SUBJECT: Fuel Tank Vent Valve Noise

MODELS: E36 with M52 Engine

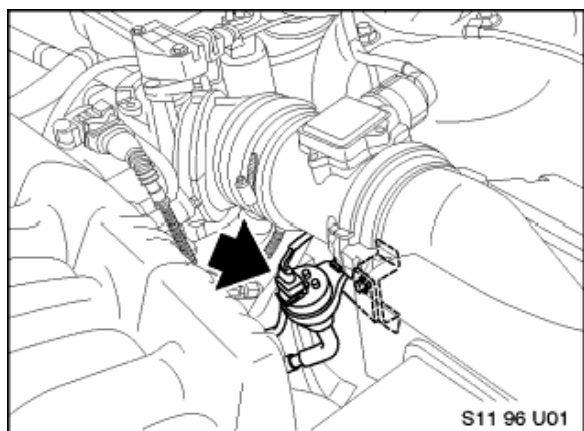
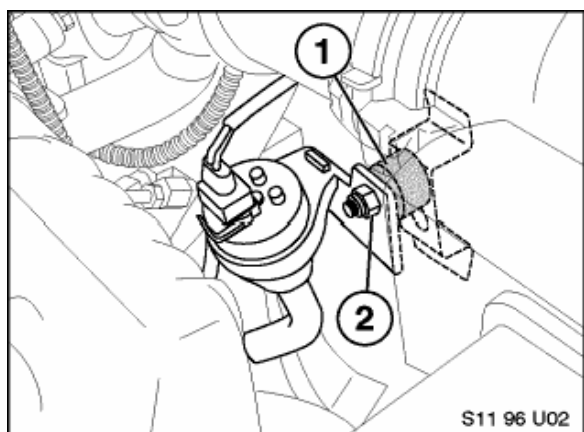
Situation: A clicking / tapping noise may be heard coming from the engine compartment which may also be described as a hydraulic valve lifter noise.

Cause: The fuel tank vent valve (TEV) located on the left front strut tower in the engine compartment, is transmitting normal operating noise through the body to the vehicles passenger compartment via the plastic mounting bracket and possibly the hose and tube routing to the bottom of the valve.

Remove the mounting bolt and fuel tank vent valve.

Install a rubber mount (1) (part number 13 71 1 259 818) in the upper threaded hole of the fuel tank vent valve mounting bracket.

Reinstall the fuel tank vent valve with plastic mounting bracket on the rubber mount stud and secure using an M6 lock nut (2).

When securing the fuel tank vent valve to the rubber mount, the valve must be positioned with the electrical connector at the top and the hose / tube connections at the bottom of the valve shown in the illustrations above. Assure that the hose and tube do not contact the body in the area of the mounting bracket for the ABS hydraulic unit when the installation is complete.
